## Front door holder loose/makes noises

Topic number	LI72.00-N-048943
Version	3
Design group	72.00 General
Date	06-19-2017
Validity	Up to 906.### 15 140904
Reason for change	Distribution revised
Reason for block

IMG\_0207.jpg:

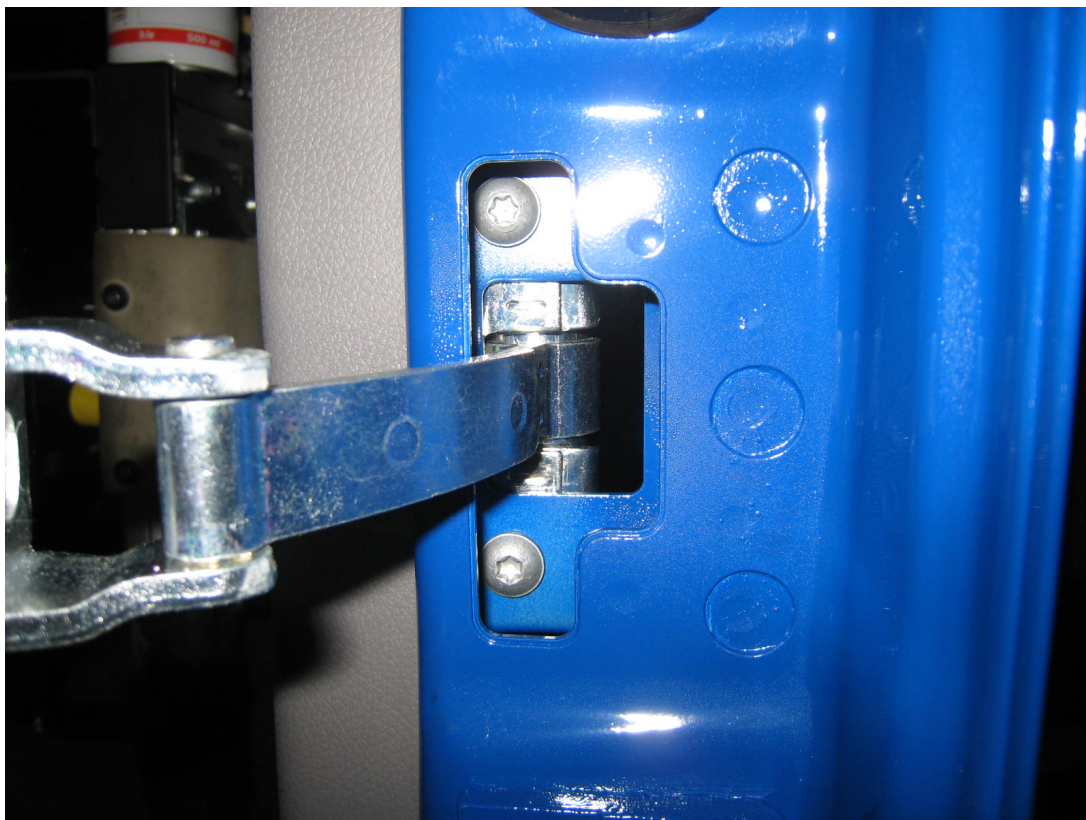
The threaded connection of the door holder undergoes a settling effect and can work loose under certain operating conditions.

The threaded connection of the door holder must be replaced by new microencapsulated bolts on the door and frame sides.

The bolt (M8), door holder to A-pillar, is to be tightened to a torque of 30 Nm.

The bolts (M6), door holder to hinged door, are to be tightened to a torque of 16 Nm.
